DC/20/02052 Castle Hill, Thorndon Planning Application
Calculation of Traffic Volumes

3) Comments on SCC Highways recommendations regarding DC/20/02052 Thorndon Planning Application – 7/7/20 (Ref:SCC/CON/2363/20)

Stradbroke Parish Council and Thorndon Parish Council

KAB 12|

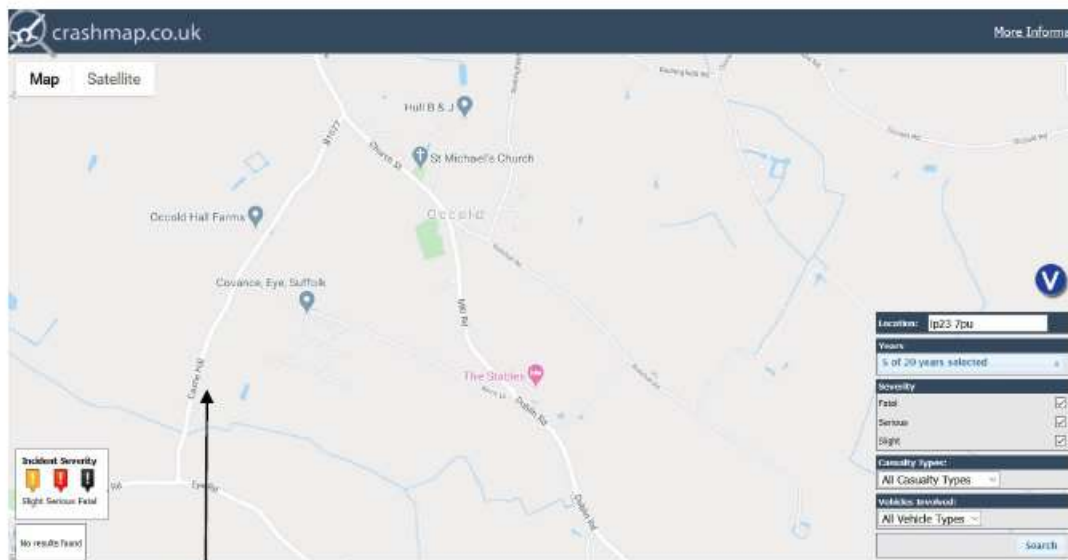
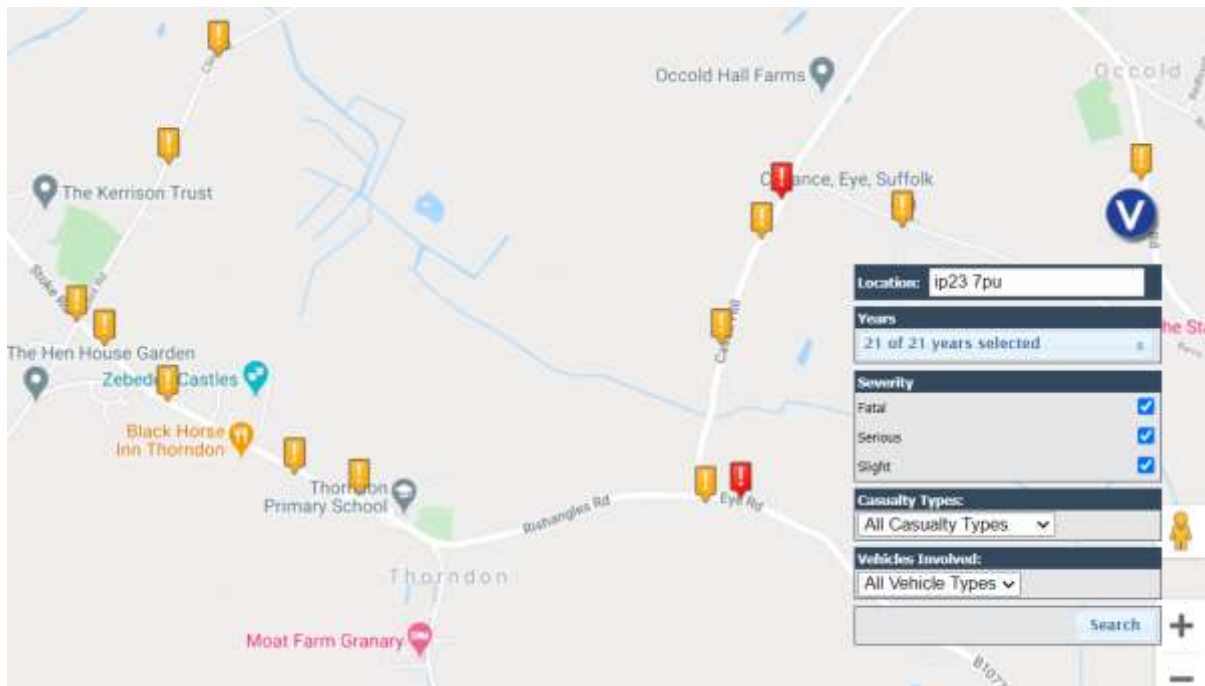
As noted above Page 6 para 1.11, Page 10 para 2.03 and Page 17 para 3.01 of the submitted HTTC report quotes data over a 20 year period and refers to KAB 12, however KAB 12 shows maps that are taken from a 5 year period only with no indication which 5 year period has been selected:

Five years collision record.
No collisions recorded along B1077 in the vicinity of the existing site access
or on nearby highway network

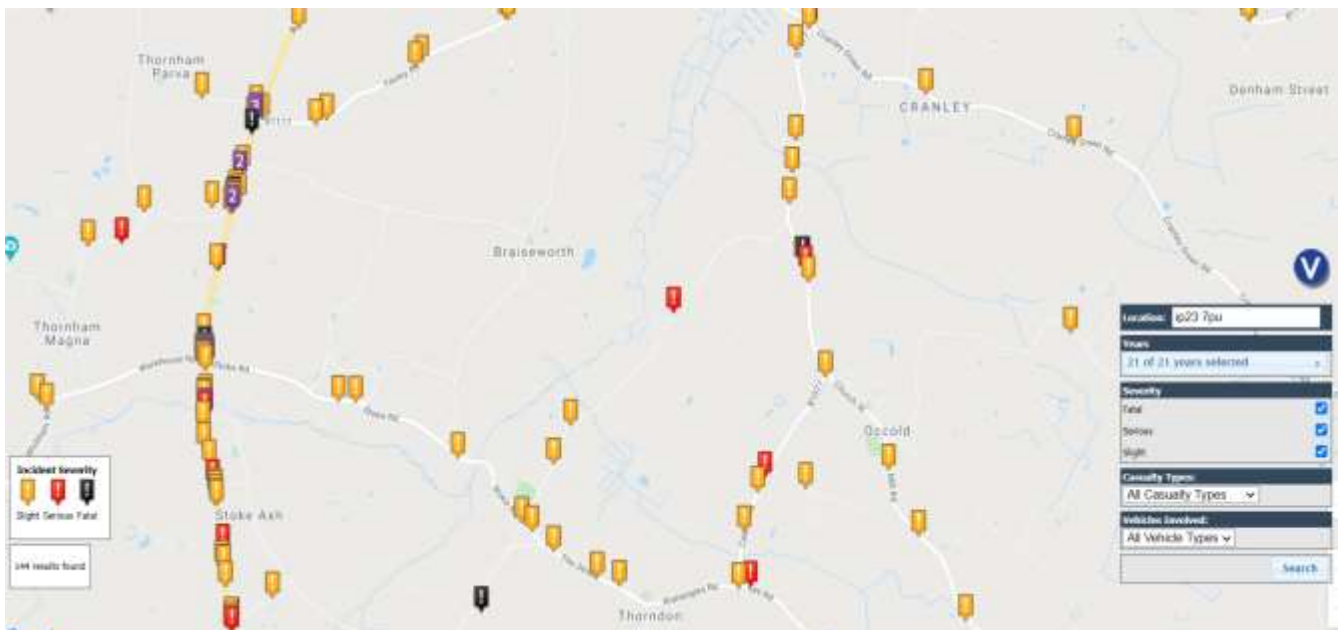
CRASHMAP UK – the full 21 year record shows the following collisions/accidents:
